Westinghouse Electric Corporation

NS-TMA-2273

SUBJECT: Boron Dilution Concerns at Cold and Hot Shutdown

FIGURE A-1

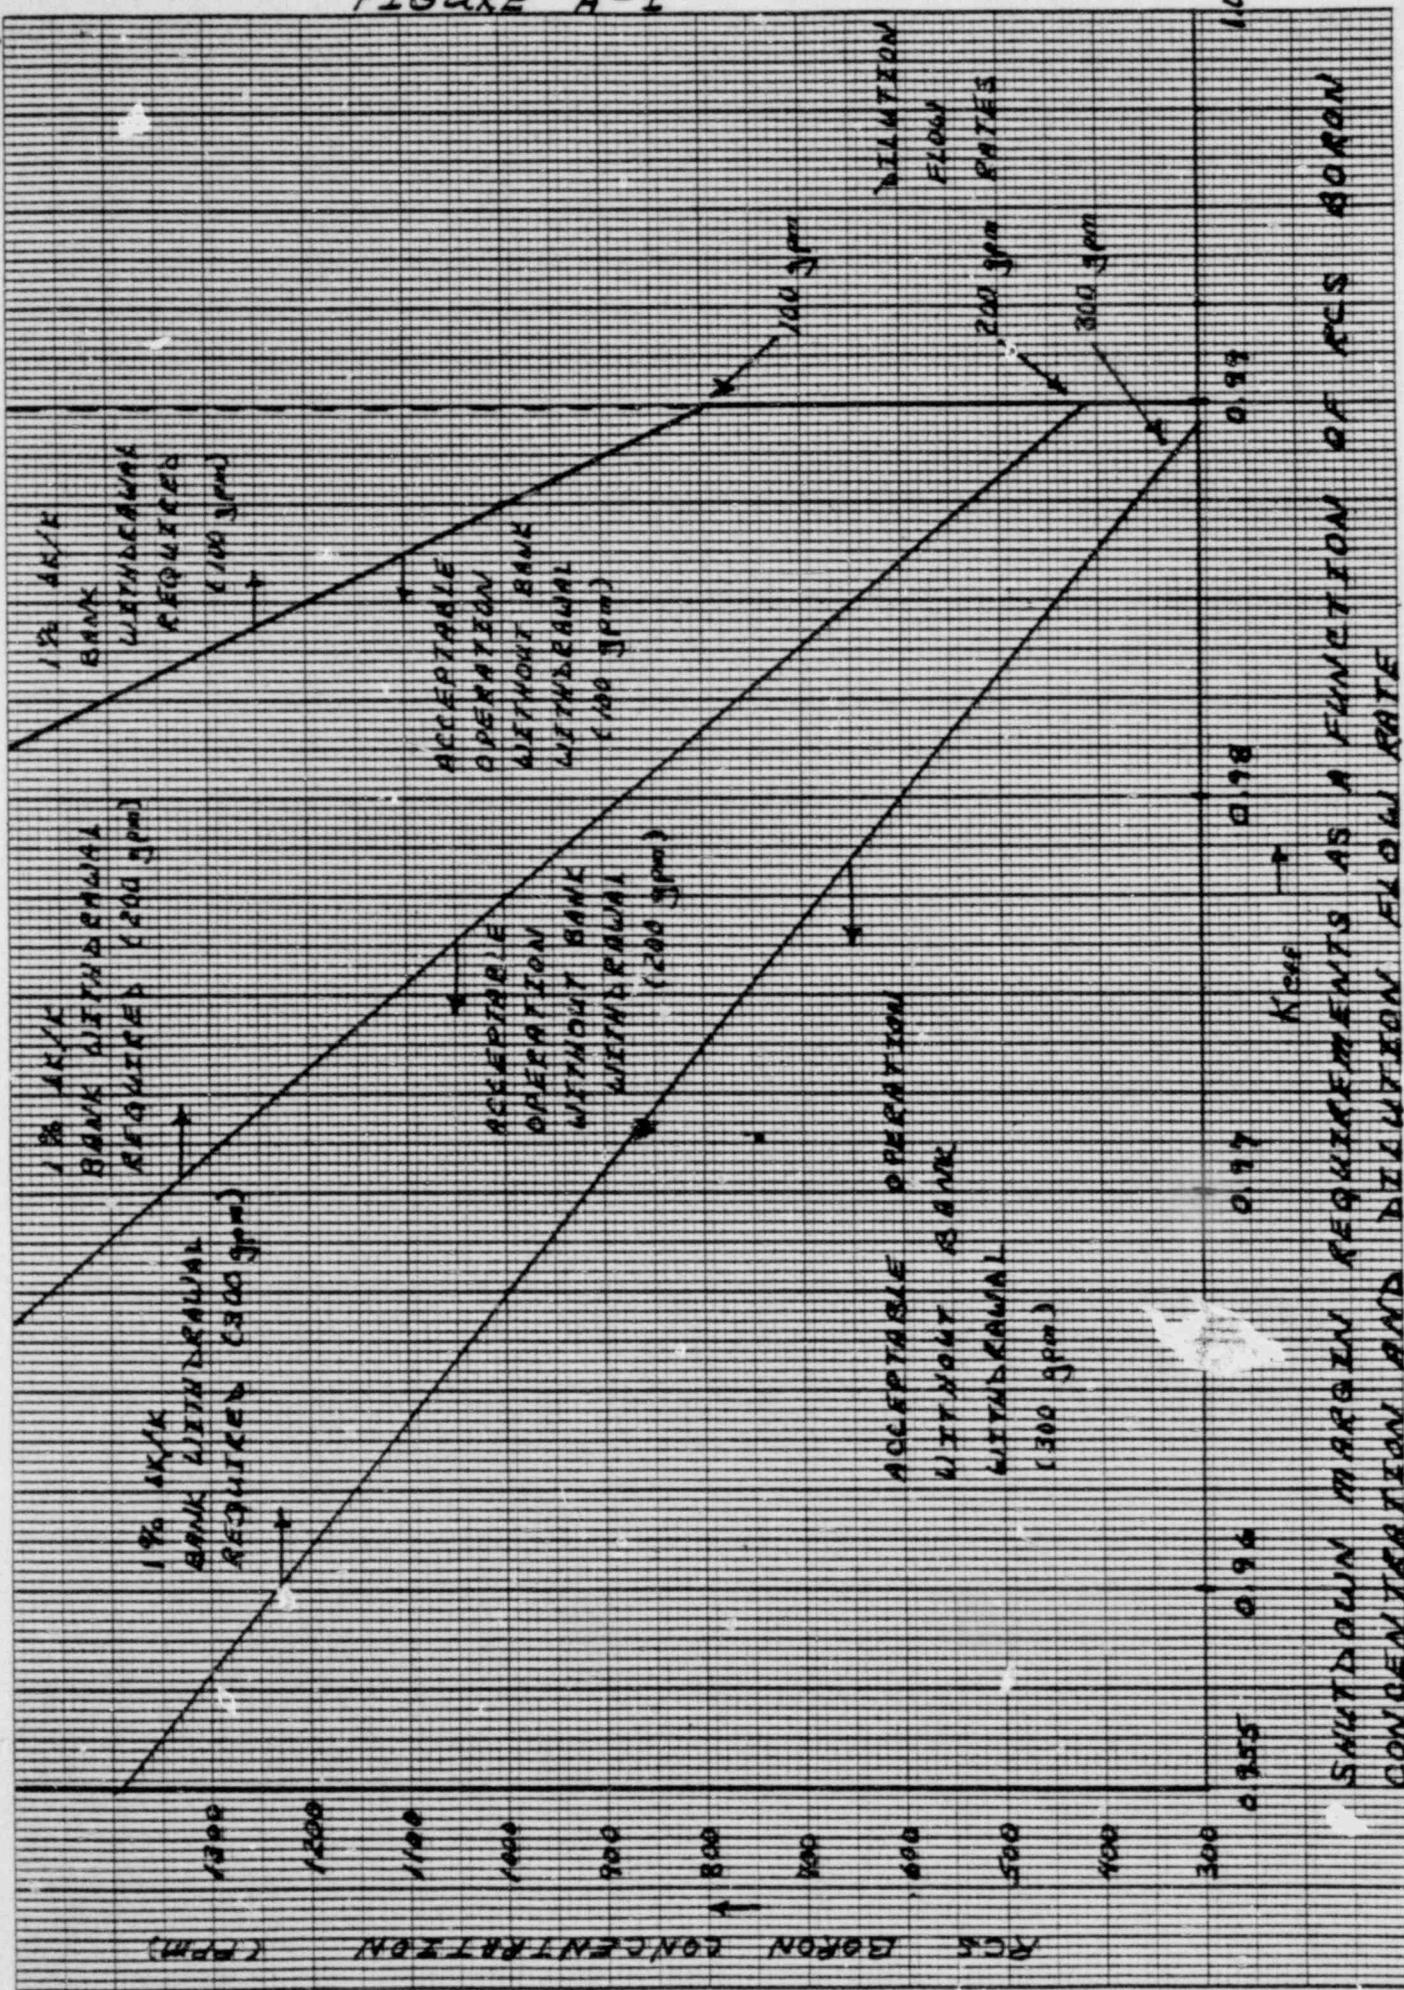
Figure A-1, attached, provides the shutdown margin requirements as a function of Reactor Coolant System boron concentration and maximum possible dilution flow rate. Prior to use of this figure, the plant must determine the maximum dilution flow rate of all charging pumps not rendered inoperable once the plant is placed on RHR. To cover all modes, it should be assumed that the flow rate is based on pump runout unless there are flow limiting devices in the system (orifices, piping resistances, etc.). The Reactor Makeup Water pump capacity may be limiting in the determination of the maximum possible dilution flow rate.

Figure A-1 notes areas of acceptable operation of three different dilution flow rates as a function of RCS boron concentration and borated shutdown margin (K_{eff}). For a given dilution flow rate, if the RCS boron concentration and shutdown margin result in a point placed to the left of the flow rate line, no control rod bank withdrawal is necessary. If the results place the plant to the right of the line, then either the shutdown margin must be increased such that the plant is moved to the area of acceptable operation, or 1% $\Delta k/k$ in control rods must be withdrawn to provide additional shutdown margin. The tripping of the withdrawn rods provides positive operator indication that a dilution event is in progress and additional time for operator termination of the event. In all cases, a shutdown margin of 5% $\Delta k/k$ ($K_{eff} \leq 0.95$) is considered sufficient for continued operation without a requirement for control rod bank withdrawal.

Figure A-1 is based on best estimate calculations for the "all rods in" configuration. It is recommended that the Westinghouse Nuclear Design Report for your plant be used as a reference in determining the RCS boron concentration with the appropriate conservatism to be used in the figure. The Westinghouse Nuclear Fuel Division is available to provide assistance in meeting the constraints imposed by the Figure A-1 requirements.

Use of Figure A-1 is applicable any time there is boration/dilution capability from the normal boric acid blending system. The above procedure is not required if boration and/or makeup during cold and hot shutdown is performed utilizing water from the RWST. This requires that the normal dilution/boration path is isolated from the charging path. Two means of lockout to isolate the charging path are available:
